ZAYO'S PRINEVILLE TO RENO PROJECT

CPUC MINOR PROJECT REFINEMENT FORM

Date Requested: 15 Oct 2024 submitted to CPUC on October 21, 2024	Report No.: 5
Date Approved: 10/25/2024	Approval Agency: Caltrans, in addition to CPUC
Property Owner(s): Caltrans (State Route 395 ROW)	Location/Milepost: PM M-29.7 to M-32.5 (S to N)
Land Use/Vegetative Cover: Ruderal (maintained highway shoulder near edge of pavement)	Sensitive Resources: Waterways at culverts to be avoided by boring underneath culverts. Cultural resources will still need to be avoided. (See project webmap.)

SHEET NO.: 67 OF 94

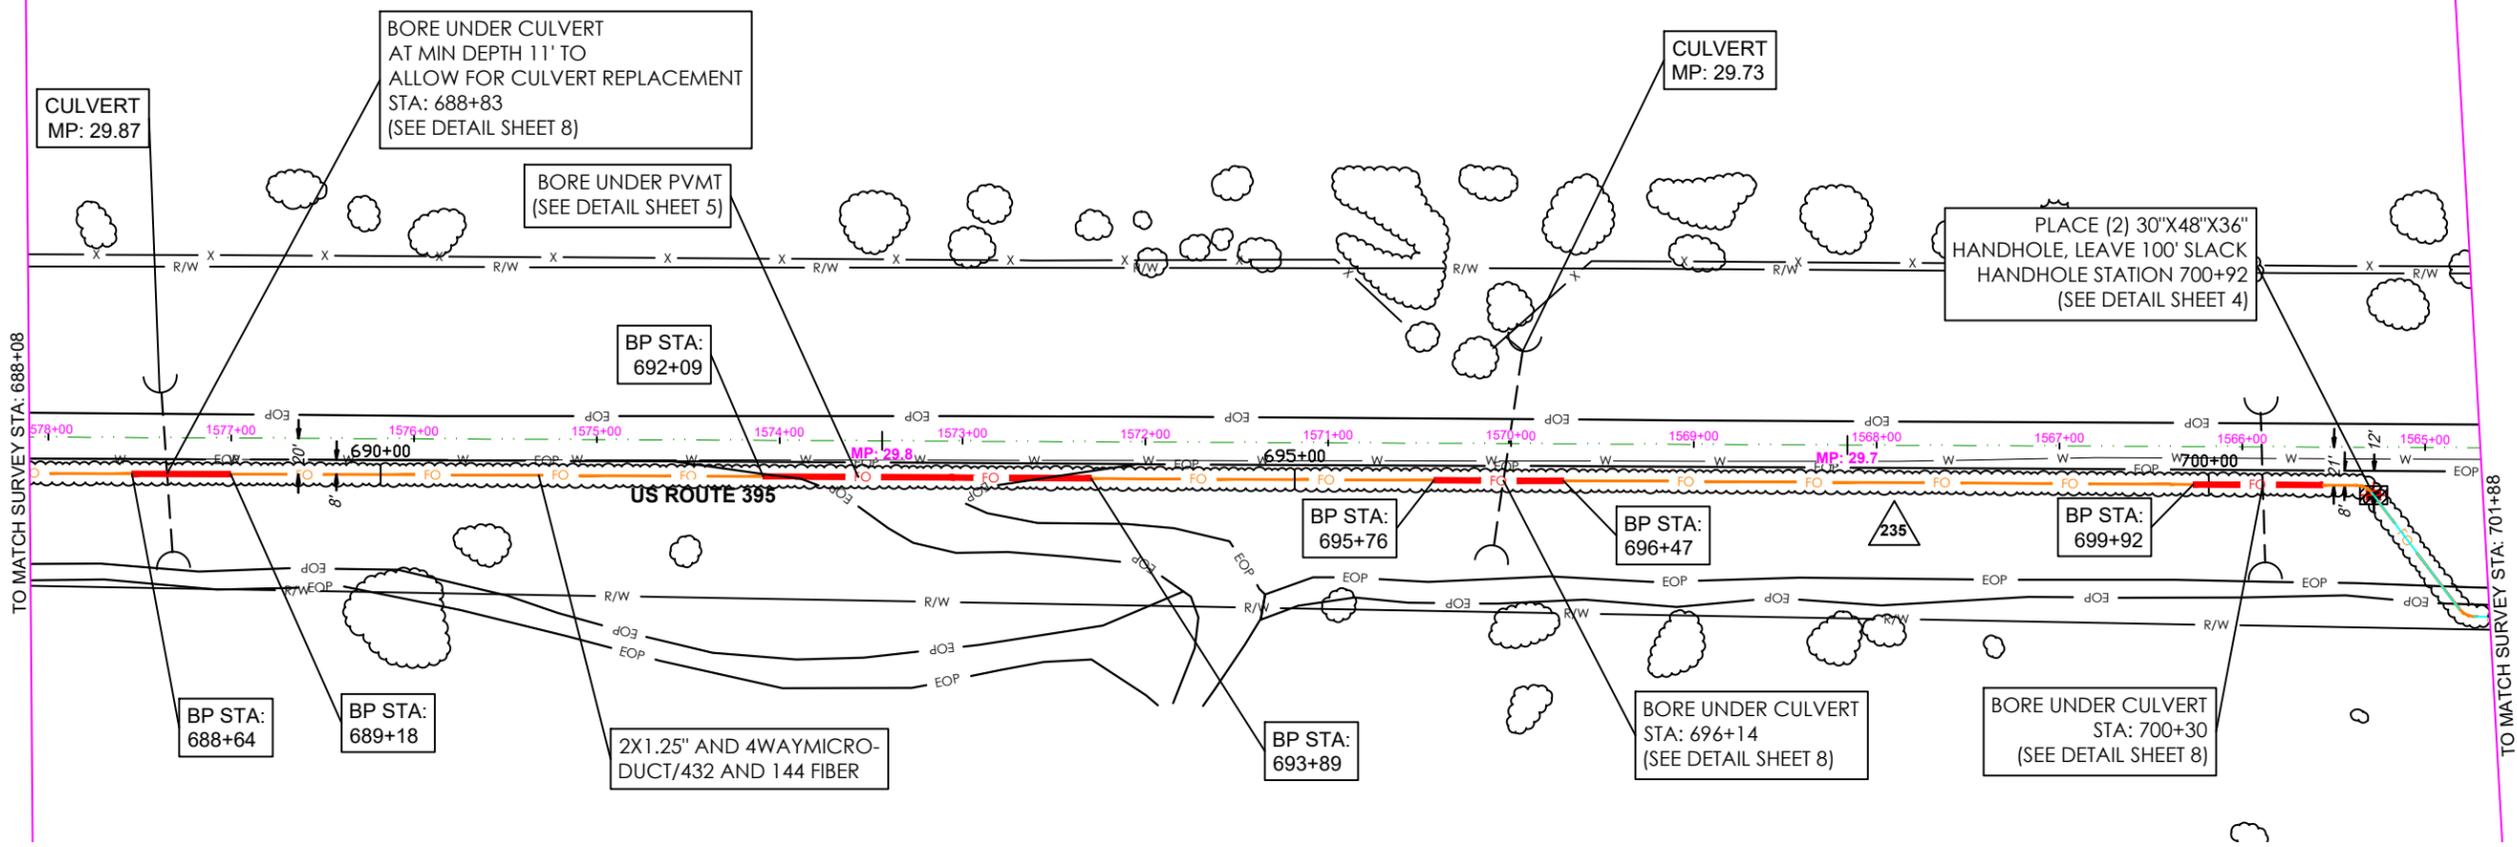
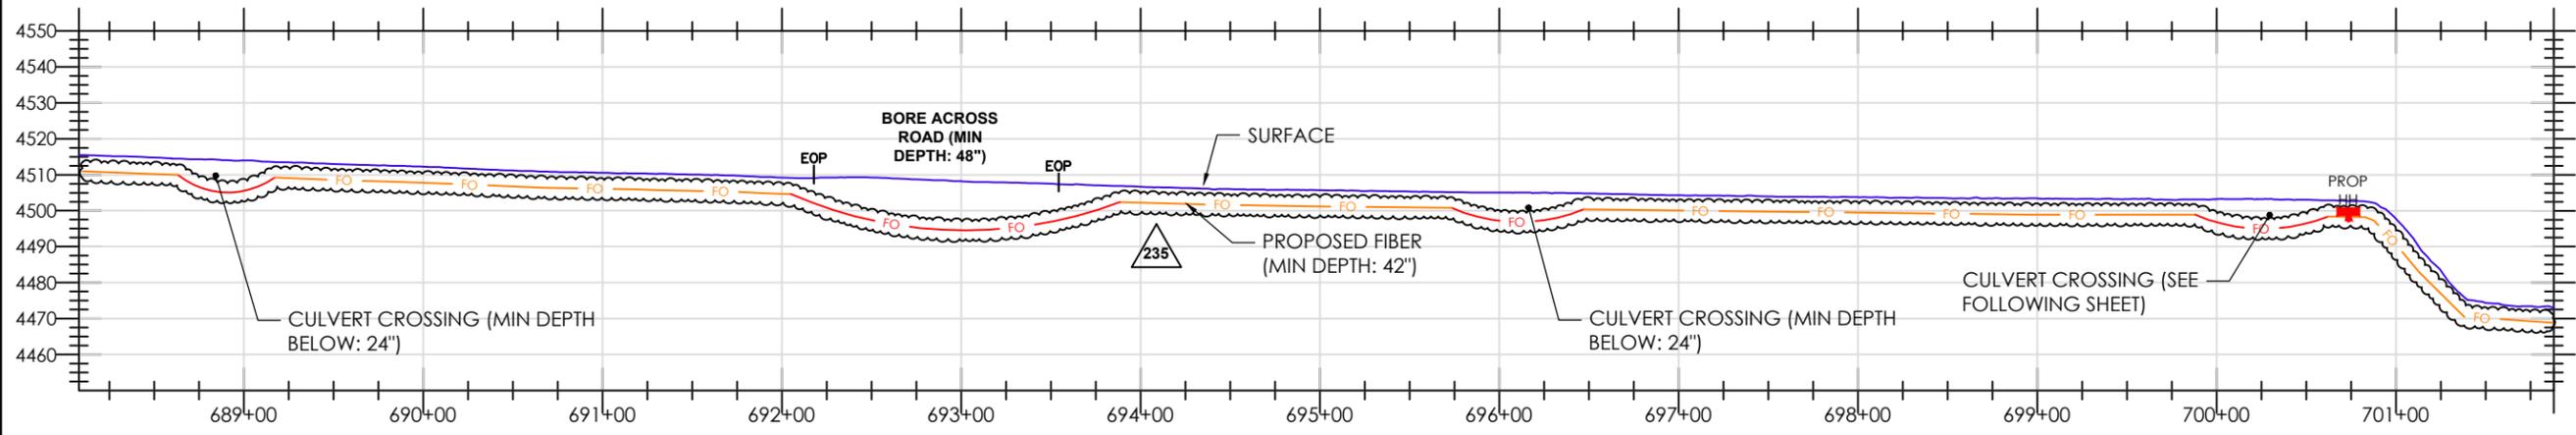
RFI NO. 0235
KEEP R/L ON WEST SIDE
8 FEET FROM EOP
STA 619+90 TO STA 701+17
